## **Technical Bulletin N°5**

REFERENCE	BT_2014_FR16_5_UK
DATE	27 August 2014
SUBJECT	Wheel stud locking system, upgraded fuel tank release
PART	Wheel stud lock, fuel tank

G04-17B019V1 Wheel Stud Lock

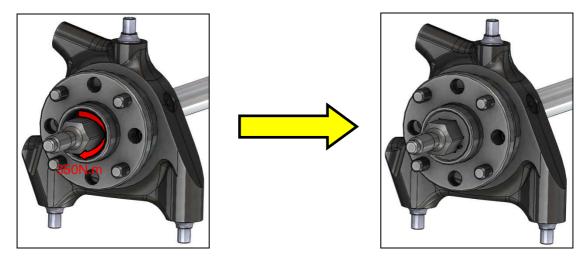
In order to secure the rear Wheel Studs (**G04-17B008V2 Wheel Stud**) mounting, a new part (**G04-17B019V1 Wheel Stud Lock**) is now available and <u>must be</u> mounted from August 30<sup>th</sup>, 2014 on the <u>left rear wheel</u> of the car.

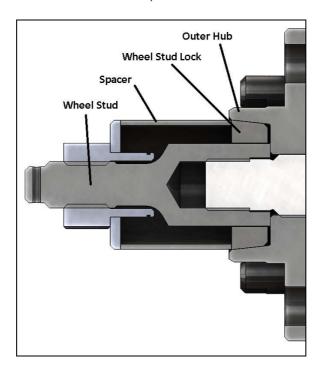
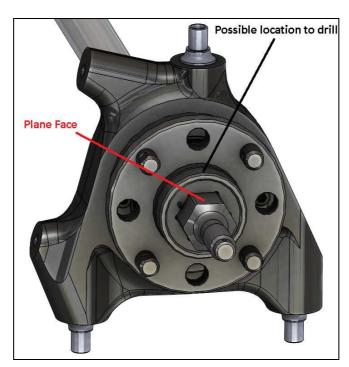
- Prior to assembly, check transmission and hub parts from wear and ensure that they are in good conditions.
- Proceed to the upright assembly tightening the Wheel Stud to 350 N.m (and not to 180N.m) and bonding the Wheel Stud using Loctite 270.
- Place the Wheel Stud Lock as shown in the picture below positioning the countersunk face inward and push it as much as you can into the Outer Hub.

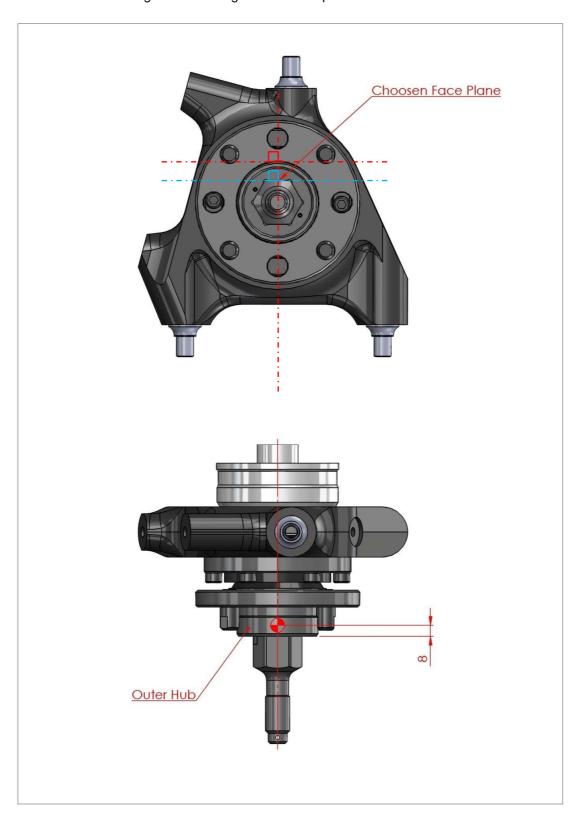
• Choose a location onto the wheel centering surface of the Outer Hub to drill a Ø5 mm hole ensuring that the hole is drilled perpendicularly to a Wheel Stud plane face as shown on the picture below:

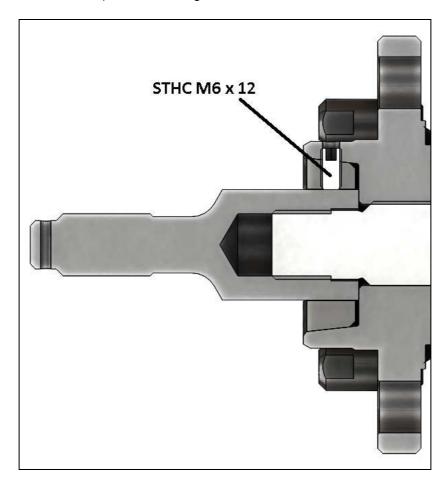
• Drill the Ø5 mm hole according to the drawing below for the position of the hole

- Drill until you start to drill the Wheel Stud Lock ( 4-5 mm maximum)
- Remove the Wheel Stud Lock and finish drilling it through.
- Put the Wheel Stud Lock back in its place (be sure that the two Ø5 holes are exactly in front of each other) and block it as previously
- Start to thread in M6 the two parts together. As for the drilling, thread to 4-5 mm maximum the Wheel Stud Lock
- Remove the Wheel Stud Lock and finish the M6 thread
- When the M6 thread is finished, put the Wheel Stud Lock back in its place and mount and tight the STHC M6 x 12 (G04-21A081V1 STHC M6 x 12) at 10 Nm using Loctite 243

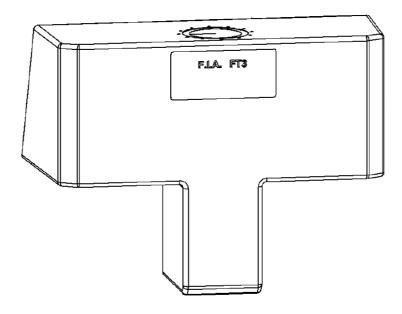
- Untighten and remove the screw STHC M6x12
- Remove the Wheel Stud Lock with the help of two CHC M3 x 25 as per the photo below

Two screws CHC M3x25 may be mounted in the two M3 threatened holes to remove the Wheel Stud Lock when necessary.
